REVISED CLEANUP PLAN SOUTH PLANT SITE

Trinity Industries, Inc.
Greenville, Pennsylvania

VOLUME 2 OF 4

**RE: RESPONSE TO COMMENTS
CLEANUP PLAN-SOUTH PLANT SITE - DISAPPROVAL
TRINITY INDUSTRIES, INC. FACILITY ID NO. 731732
BOROUGH OF GREENVILLE, MERCER COUNTY**

GROUNDWATER CONTOUR MAP
MARCH 2009

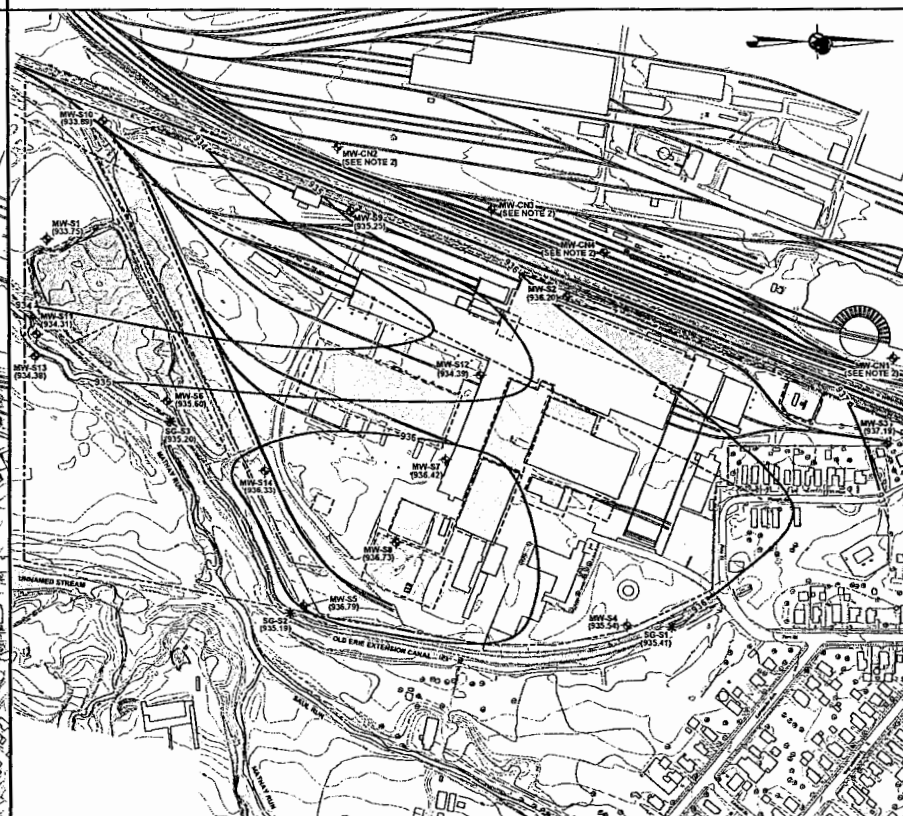
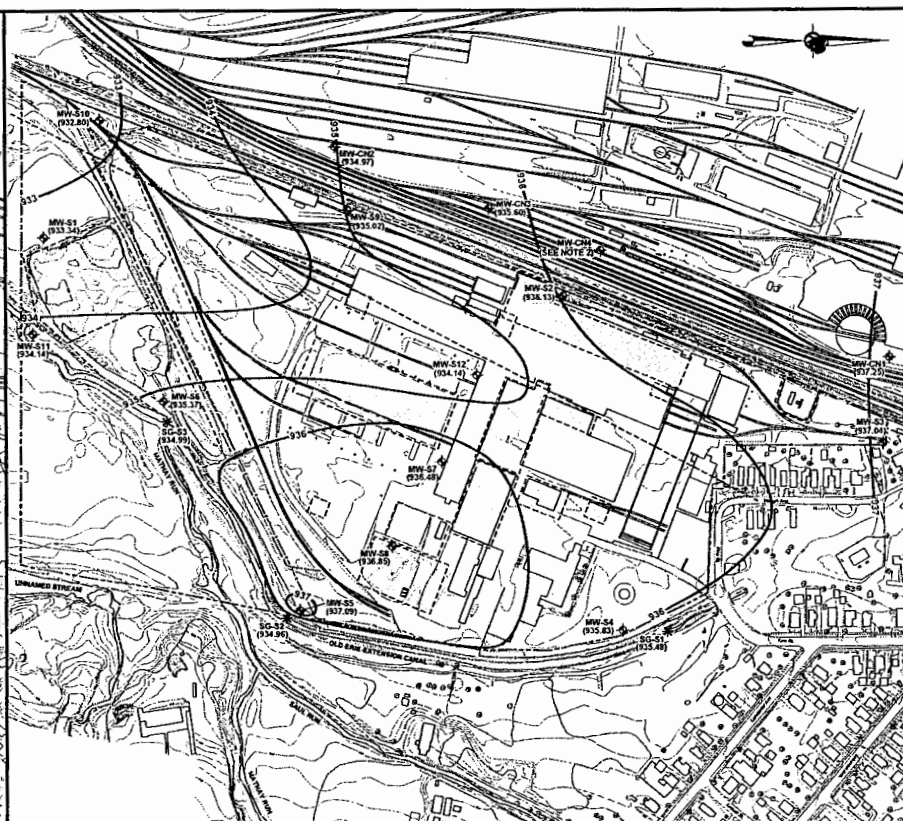
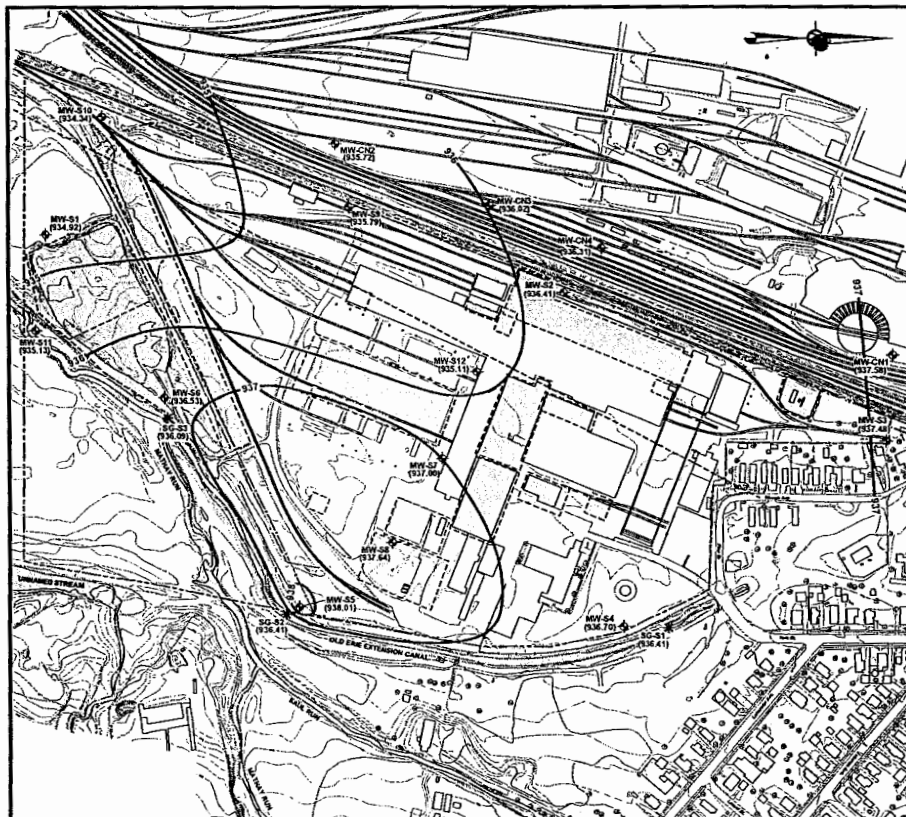
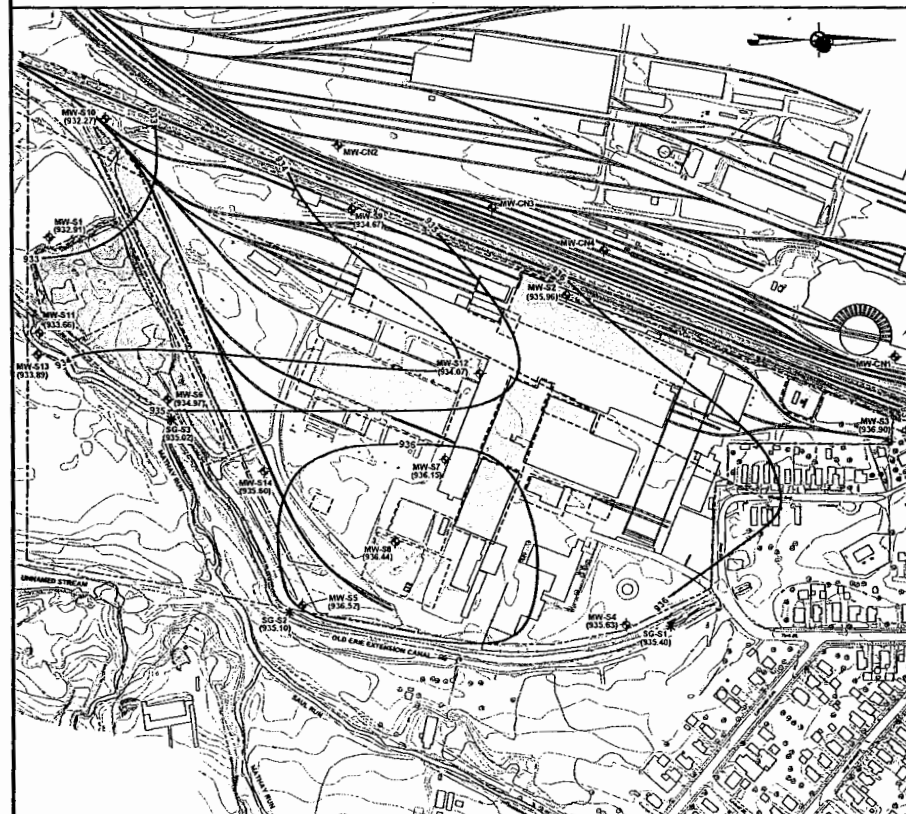
Trinity proposes to use a Site-Specific Standard of 3,600 ug/L for Manganese for groundwater migrating off-site. This proposal is contrary to Trinity's conclusion that Mathay Run and the Old Erie Canal act as a hydraulic barrier for contaminants migrating off the South Plant. Moreover, the proposal is specifically prohibited by Paragraph (6)(b) of the 2006 Consent Order and Agreement (COA) which limits Trinity to demonstrating either the Background or the Residential Used Aquifer, Statewide Health Standard at the property line and beyond.

In accordance with the approved Cleanup Work Plan, Trinity collected several rounds of water level data at the South Plant to demonstrate that groundwater is discharging to Mathay Run and that the creek is acting as a hydraulic barrier. This additional data is shown in attached Figure 5 and will be incorporated into the Revised Cleanup Plan. The data was not available for the draft Cleanup Plan that was placed in the repositories for public comment and was not added to the document in the interest of time when the document was finalized for submittal to the PADEP.

While the additional water level data show higher water levels across Mathay Run and indicate a hydraulic barrier may exist, the data is not conclusive. Therefore, Trinity will collect additional groundwater level measurements and analytical data in conjunction with the surface water sampling noted above to further verify that Mathay Run is acting as a hydraulic barrier.
